Mallory Square, Sketch Plan 320120010

staff report date: October 21, 2011

description

Detail Showing Approximate Dedication for Master-Planned Road B-10

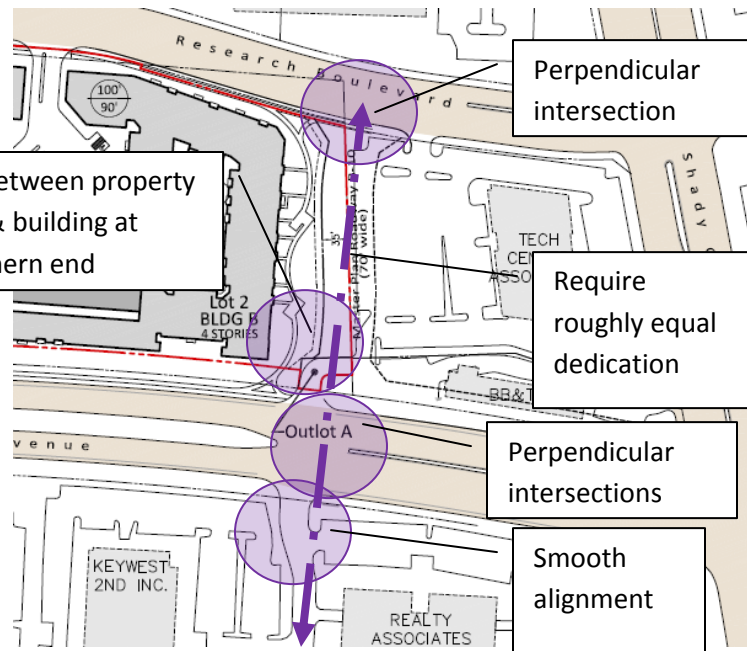
Subsequent to the plan revisions, representatives of the neighboring property owner (Tech Center Associates) provided Staff with two letters and an analysis detailing a further request: that all dedication for master-planned Road B-10 be shifted west onto the subject property.

In support of this request, the analysis provided by Tech Center Associates asserts that:

1. If the proposed alignment were to tie into the existing curb cut and median break:
 - a. Road B-10 will curve too close to the intersection with Key West Avenue;
 - b. The roadway width cannot safely accommodate vehicles;
 - c. The roadway cannot meet the design standards for travel and parking lanes;
2. If the proposed alignment were straightened and a new curb cut and median break was established:
 - a. Road B-10 will not align with the median break and entrance across Key West Avenue; and
 - b. The new curb cut required to straighten B-10 would be too close to Shady Grove Road.

1. Unsafe curve close to Key West Avenue intersection - As shown in the Sketch Plan, B-10 would be aligned with an unsafe curve approximately 45 feet north of its intersection with Key West Avenue. The curve would likely limit sight-distance and would also potentially impact operations on Key West Avenue. This could result in the potential for rear-end accidents as motorists access the site around the curve.

2. Unsafe reduction in roadway width - The alignment of B-10 shown on the sketch plan application depicts a 70-foot wide roadway cross section that reduces to a 35-foot cross section at its intersection with Key West Avenue. It is not clear how the abrupt reduction in width, particularly so close to the Key West Avenue intersection, could safely accommodate vehicles.

3. Roadway does not meet design standards – As shown in the Great Seneca Science Corridor Master Plan (June 2010), B-10 is planned to have a 70-foot right-of-way with 2 travel lanes and parking on both sides. This design at the intersection would not conform to the design standard (2005.02) that is required for this roadway.

2. New curb cut location would be located at an unsafe distance from Shady Grove Road – A new intersection on Key West Avenue at the current location of the B-10 alignment would be located too close to the Shady Grove Road intersection. Furthermore, the intersection of Key West Avenue and Shady Grove Road is planned to be upgraded to an urban diamond, grade-separated interchange per the Great Seneca Science Corridor Master Plan (June 2010) and Key West Avenue is planned to have eight through travel lanes at its intersection with B-10. The B-10/Key West Avenue intersection should be no closer than 500 feet from the interchange in order to provide safe maneuvers for traffic weaving from the diamond ramp onto Key West Avenue and traffic exiting Key West Avenue to B-10. The depicted alignment would place this new intersection at a potentially unsafe distance approximately 400 feet from the Shady Grove Road/Key West Avenue intersection/proposed interchange.

Staff considers the problems associated with the first scenario as unlikely to occur because a safe and equitable solution would require proper straightening and construction of a new curb cut and median break. Thus, the problems that need to be addressed are those associated with scenario two. While the details of volume counts, queuing, site distance, and final dedication are determined at preliminary plan review, it is important to ensure that a “best fit” is not precluded at this point.

Regarding alignment, the best fit would seem to do two things: align as close to perpendicular as possible to Research Boulevard and Key West Avenue and to remove the kink out of the drive to the south across Key West Avenue in order for B-10 to function as a proper business district street. Thus the rough center-line of the future road alignment might look like the purple line in the illustration. It is historically the practice of this Department to split new roadways whenever possible equitably between abutting properties. In this case, a new alignment such as the one depicted would be roughly equitable although angled taking more and then less from each property around a midpoint requiring an average of about 35 feet in dedication from each property.

Regarding safe distances, Staff does not agree that the intersection of B-10 and Key West Avenue should be at least 500 feet from the intersection of Key West Avenue and Shady Grove Road. While intersection spacing in a suburban environment is usually around this distance, the goal of the Sector Plan is to create a more pedestrian-oriented environment with a smaller street grid. Typically, these environments encourage small blocks – down to 300 feet. The roughly 400 feet proposed by the Application is more than many urban situations and is an accurate estimation of the alignment recommended by the Sector Plan. Further, because the intersection of Shady Grove Road and Key West Avenue will be required to be improved by any new development (due to its “failing” status), these issues can be considered more holistically. At this conceptual phase of review, it is not

recommended that the dedication of B-10 be shifted, only that no buildings or structures be designed within 70 feet of the property line within the southernmost half of this frontage.

To ensure a proper solution can be found and to maintain an existing access point for the neighboring property, the Applicant would, at the time of Preliminary Plan review:

- Finalize the proper alignment of Road B-10;
- Place the finalized right-of-way into a reservation for dedication;
- Enter into a covenant to pay for the construction of a pro-rata share of Road B-10; and
- Create an outlet over an existing access easement through the area to be dedicated that will be extinguished when the road is fully dedicated for construction.

Connectivity Exhibit

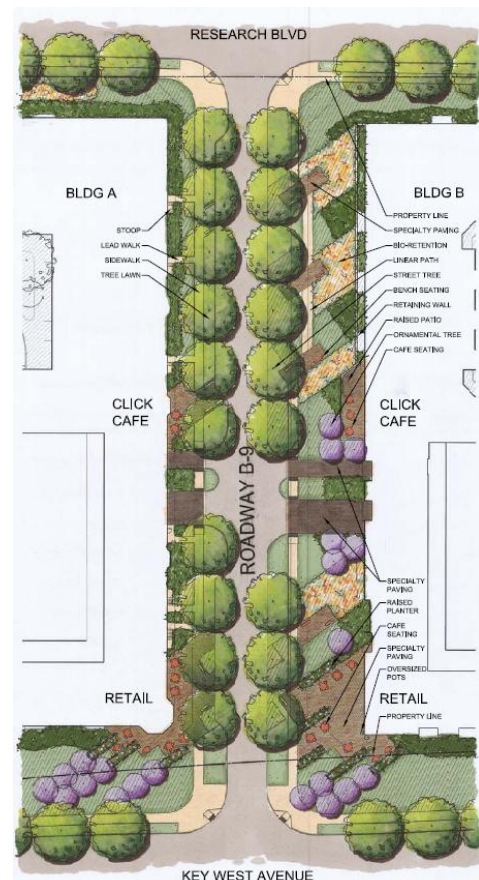
At a presentation of the project by the Applicant to the GSSC Implementation Advisory Committee, 3 primary issues were raised:

- Show how the project provides connections to other properties, sidewalks, trails, and paths and the locations of bicycle facilities;
- Show how the streetscape will be treated to ensure compatibility and minimize the footprint by building taller; and
- The Committee supports the construction of roads that will provide a street grid.

A fourth comment was put forth by members of the committee but that was not supported by the entire committee:

- Provide more retail space for neighborhood services.

To address these comments, the Applicant has provided an illustration showing sidewalks, paths, etc within proximity to the site. The streetscape is only conceptual at this point, but will provide trees, lighting, ample sidewalks, and amenities. Each frontage, however, will be treated differently due to the distinct nature of each road. Details of these treatments will be provided and analyzed during site plan review.

While retail space is encouraged by the Master Plan, there is not, as of yet, a significant market that would support this. That said, the Applicant is planning on provision of three or four retail bays to ensure that at least ten basic services are within ¼ mile of the site. If the market is stronger than expected after the first building is completed, retail in the second building may be increased. This flexibility is built into the approval limits on residential and commercial density.
